**STAFF SUMMARY REPORT (ALEC NAUGLE)
MEETING DATE: April 9, 2008**

SUBJECT: **SFPP, L.P., AN OPERATING PARTNER OF KINDER MORGAN ENERGY PARTNERS, L.P., for the SFPP, L.P. BRISBANE TERMINAL, BRISBANE, SAN MATEO** – Adoption of Updated Site Cleanup Requirements

REVISED TENTATIVE ORDER

**Water Board Response to Comments Received on the
Draft Tentative Order
(Site Cleanup Requirements)**

**Figure 4b Dissolved MTBE
 Isoconcentration Map -
 April 10 through 12, 2007**

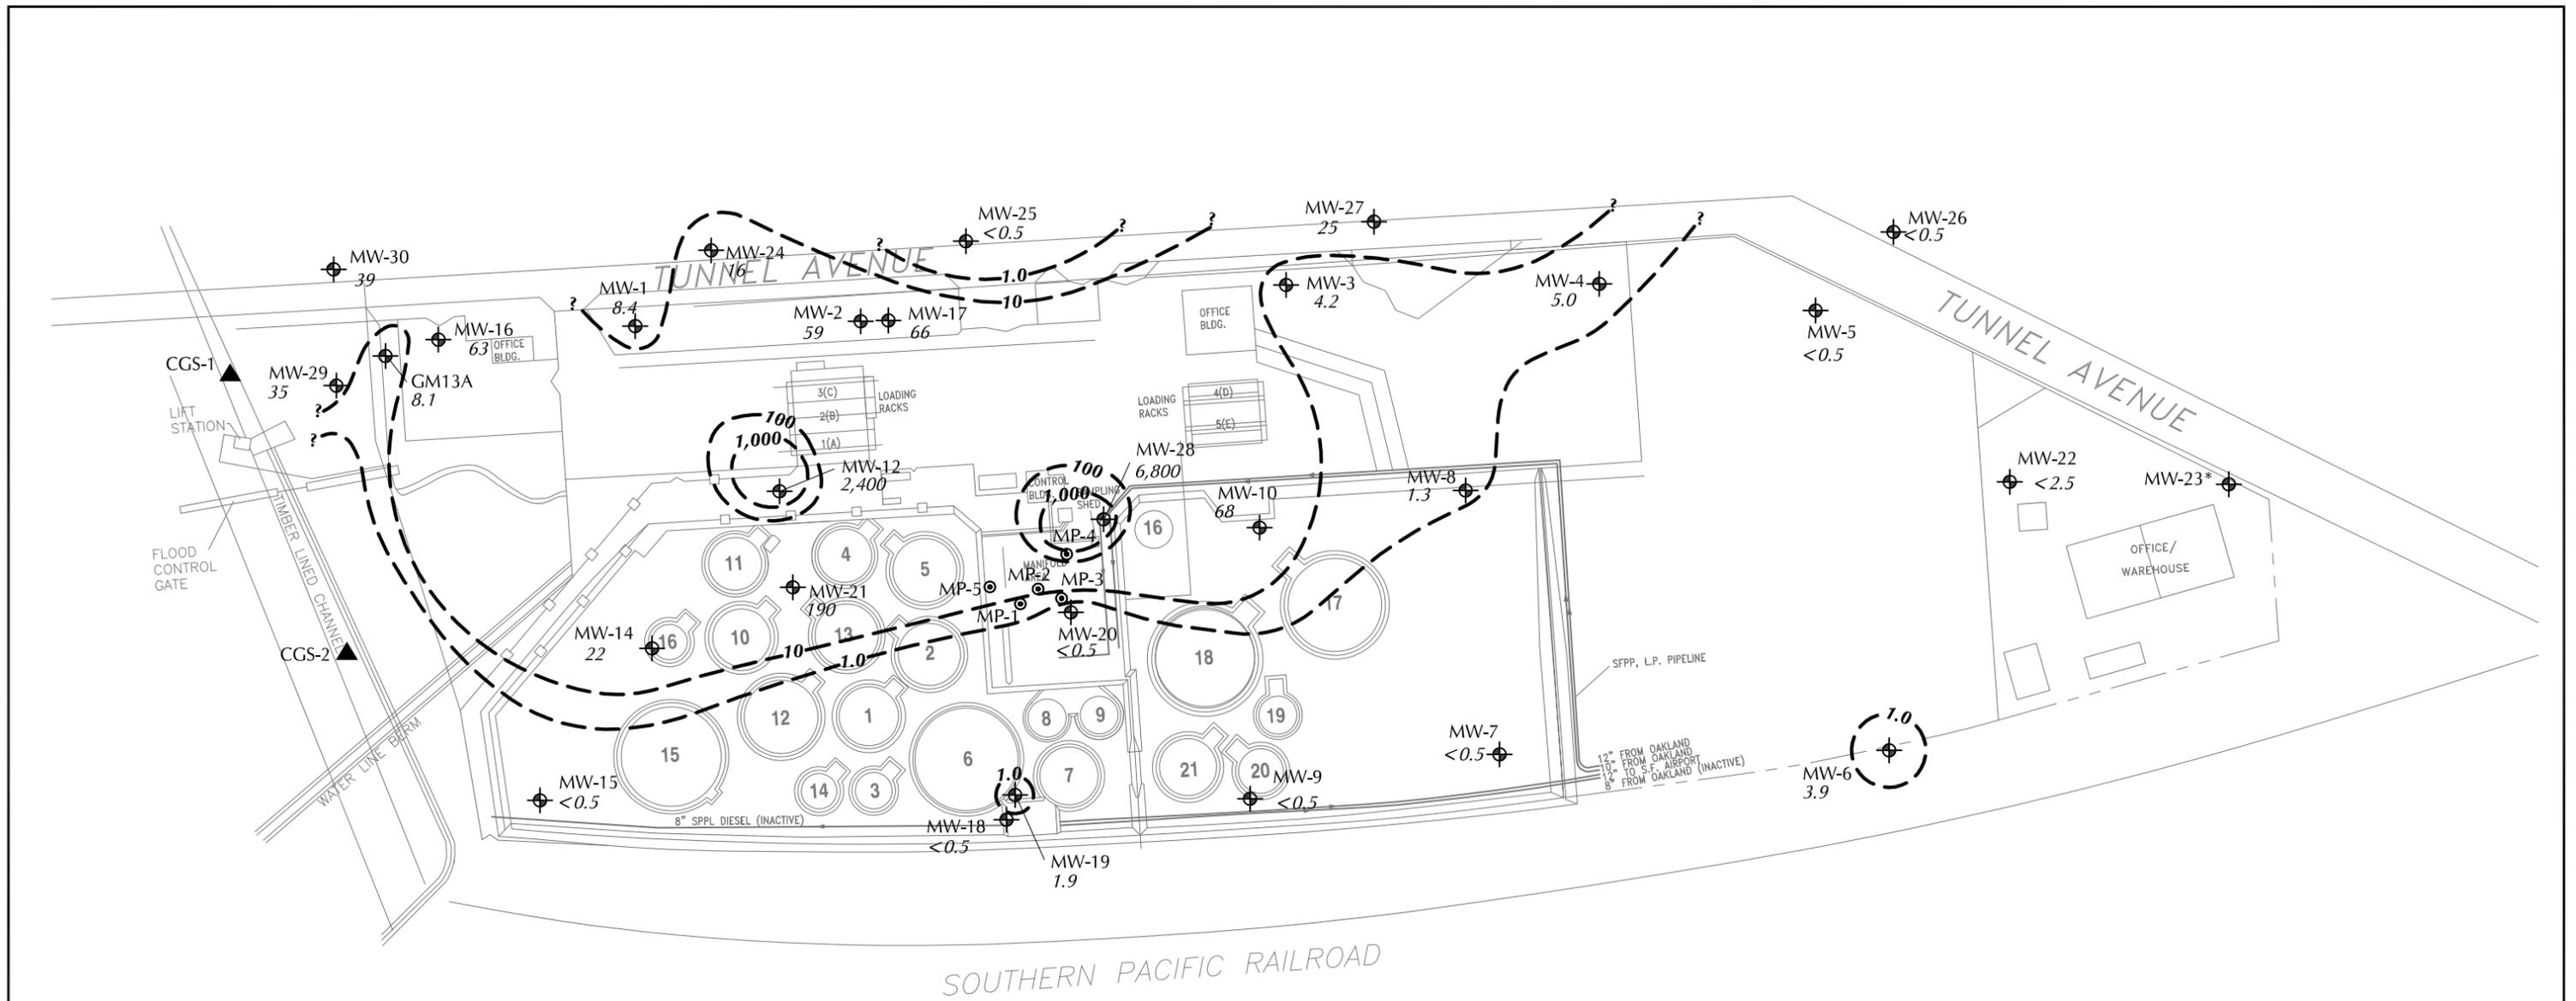
2-figure 4b-10 Why isn't the extent of the MTBE plume area shown more dramatically? It is clearly larger. More wells are needed all around the facility. I notice that the plume is moving toward the Lagoon and it is in the Landfill.

**Figure 4d Dissolved Benzene
 Isoconcentration Map
 April 10 through 12, 2007**

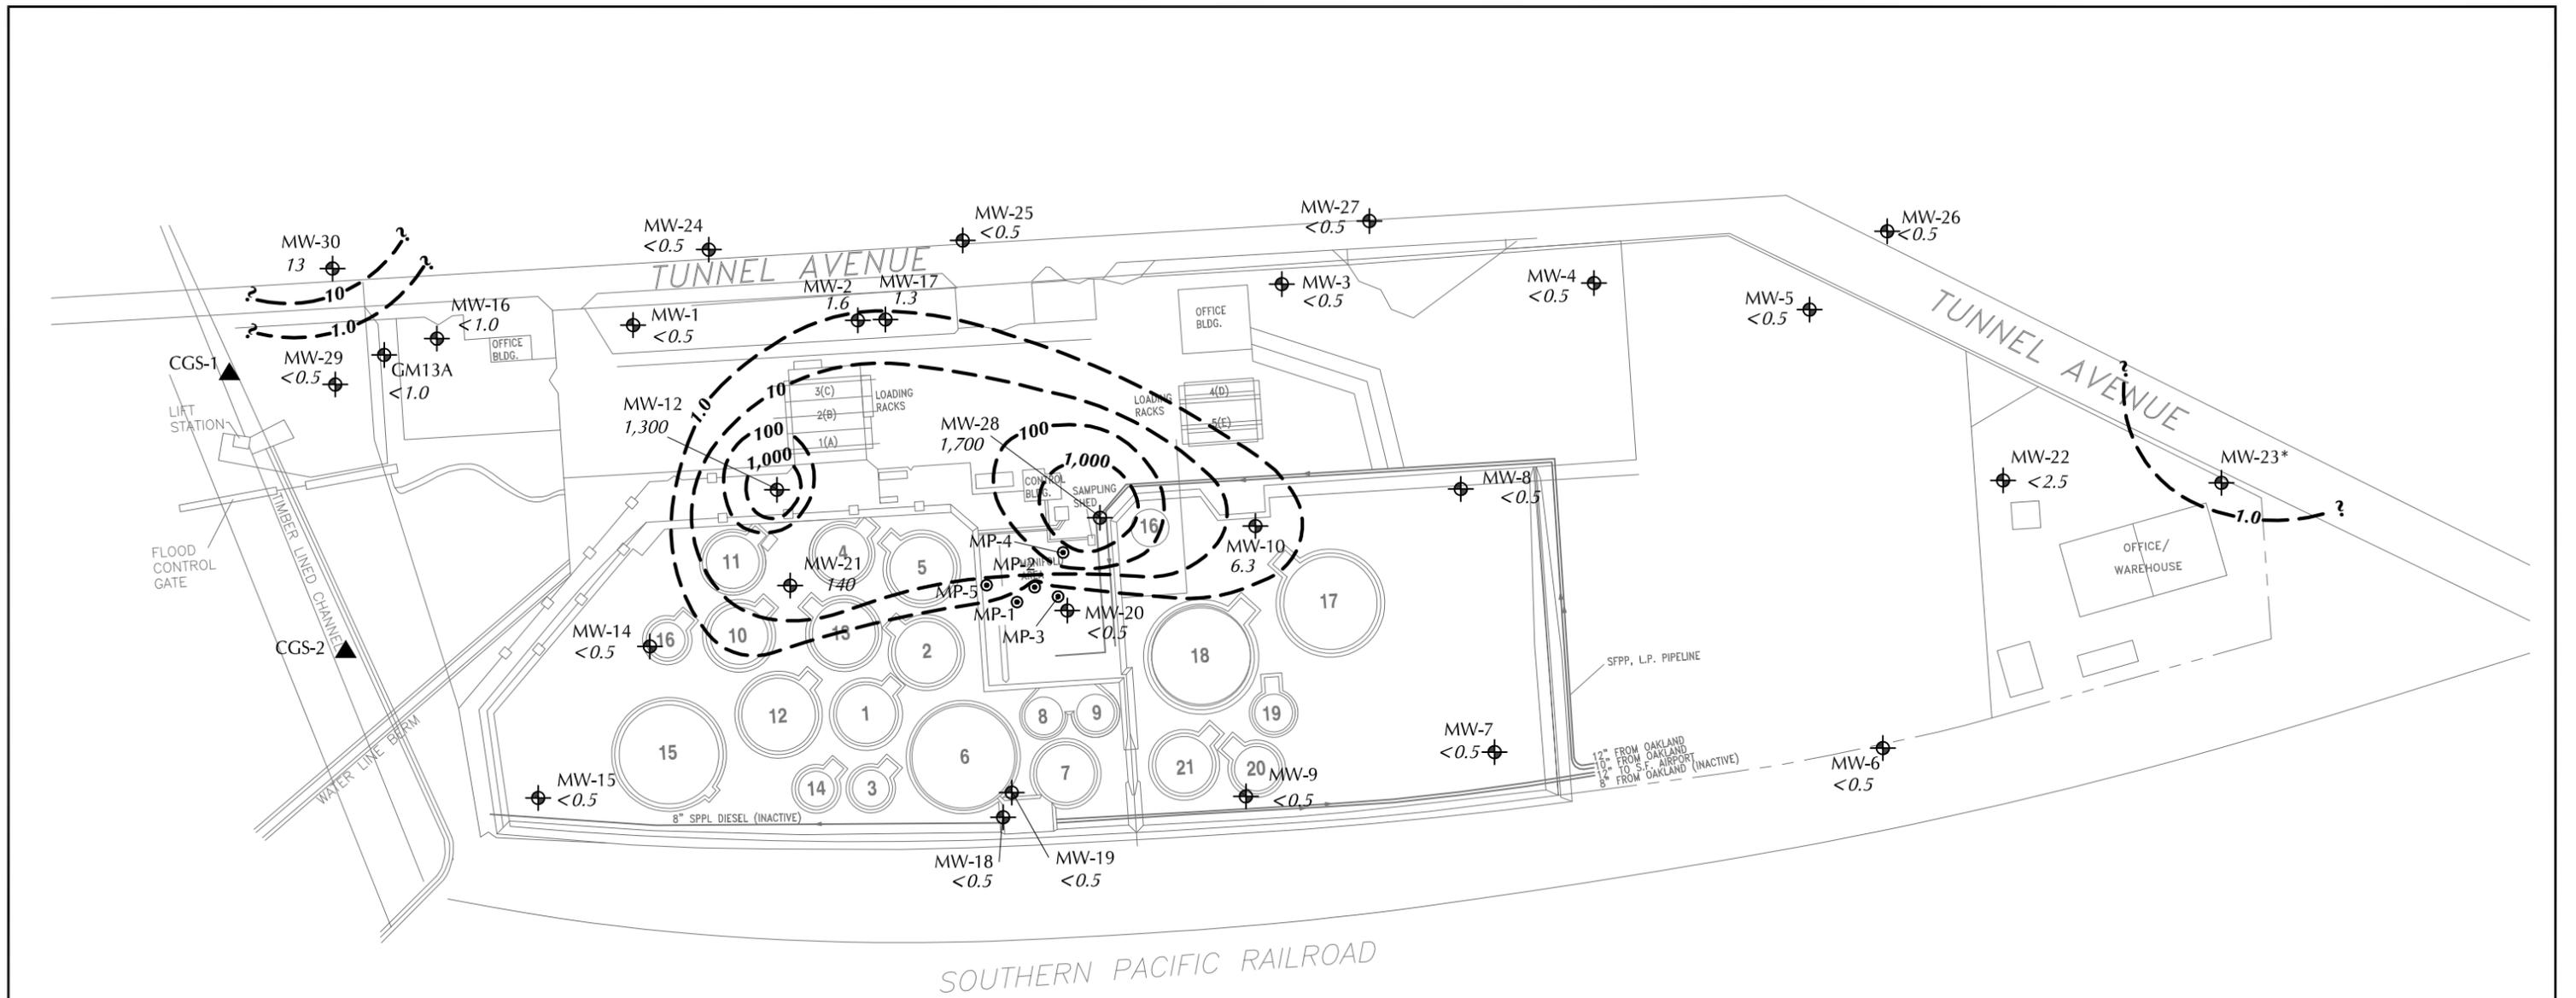
2-Figure 4d-11 The Benzene plume is also in the Landfill area across Tunnel Avenue and it is moving even closer to the Lagoon than the MTBE is. Is this order going to keep the Benzene and MTBE from reaching the Lagoon. The last 10 years have seen substantial enlargements of the plumes.
